## MEMORANDUM

**SUBJECT:** Variation Request – 1431 Monroe Avenue

**APPLICATION FOR ZONING VARIATION**  
**Village of River Forest Zoning Board of Appeals**

Address of Subject Property: 1431 Monroe Avenue River Forest, IL 60305

**PROPOSED SITE PLAN  
NO SCALE**

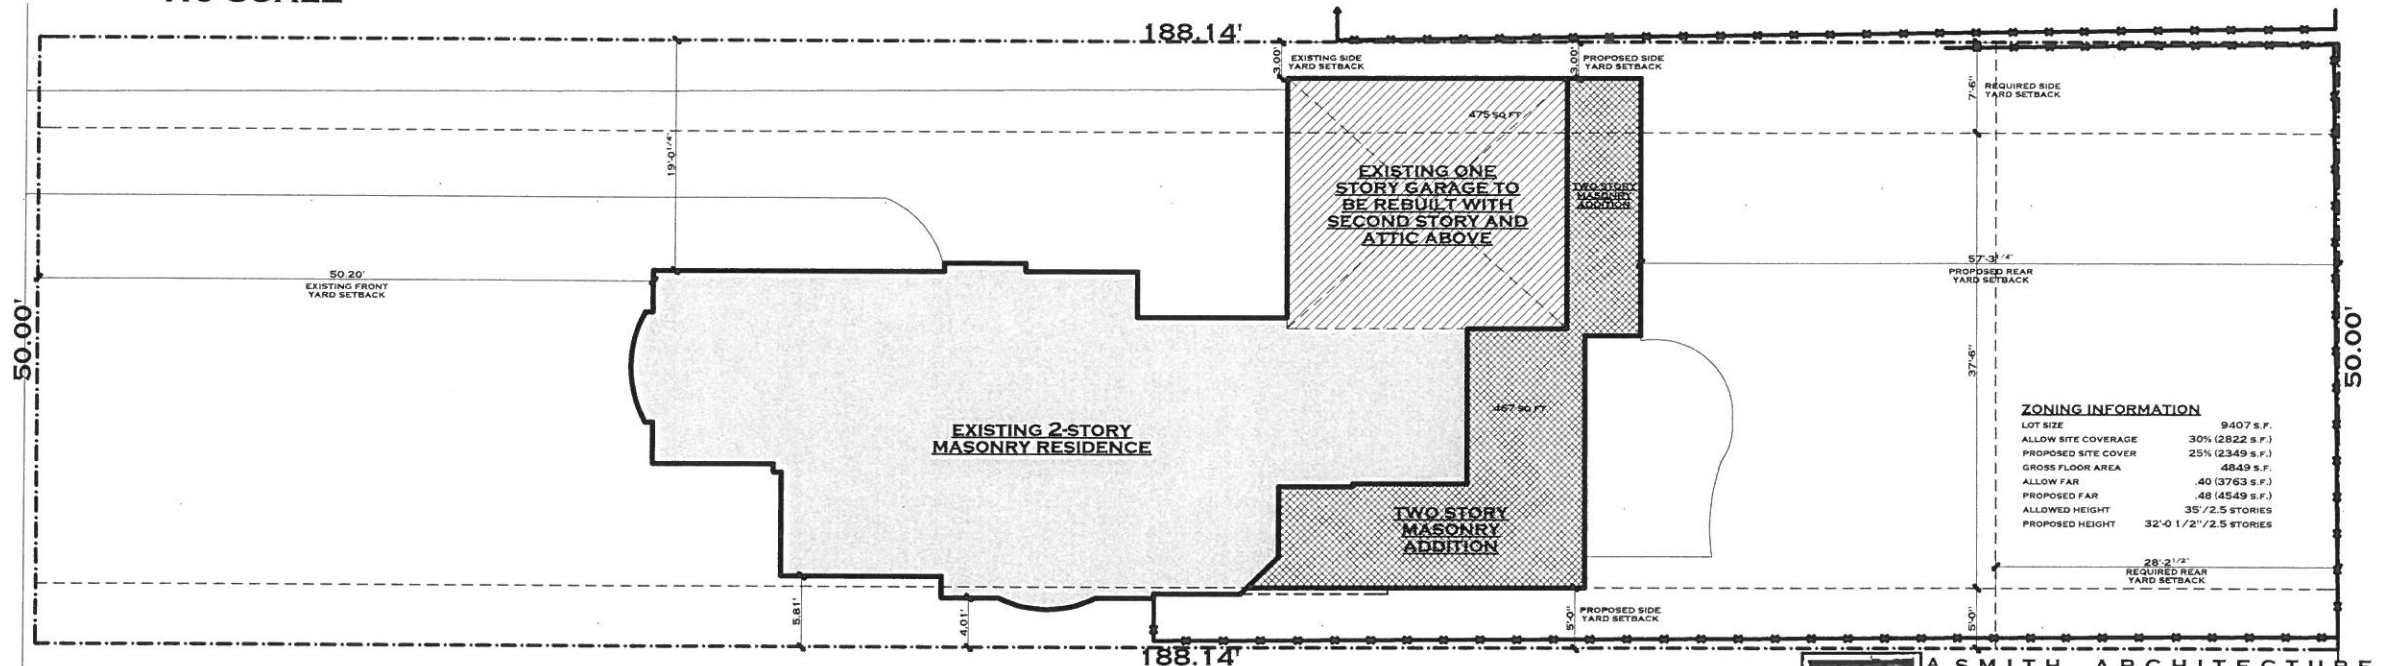
The applicants are requesting variations so that the existing one-story north wall of the building, which maintains a non-conforming side yard setback of 3'-0", may be demolished and replaced with a new two-story wall at the same non-conforming setback.

The proposed addition will have a 5'-0" setback from the south property line, so that the combined side yard setback for the addition will only be 8'-0". Note that the setback of the existing house at the south side of the building is 3.15 feet (slightly less than 3'-2"). The overall combined side yard setback is 6.15 feet, which will be reproduced by the proposed addition.

The setback of roof eaves from the side property line is required to be 3'-0". The proposed roof overhang of 6 inches will result in a setback of 2'-6" to the roof eave at the north side of the addition.
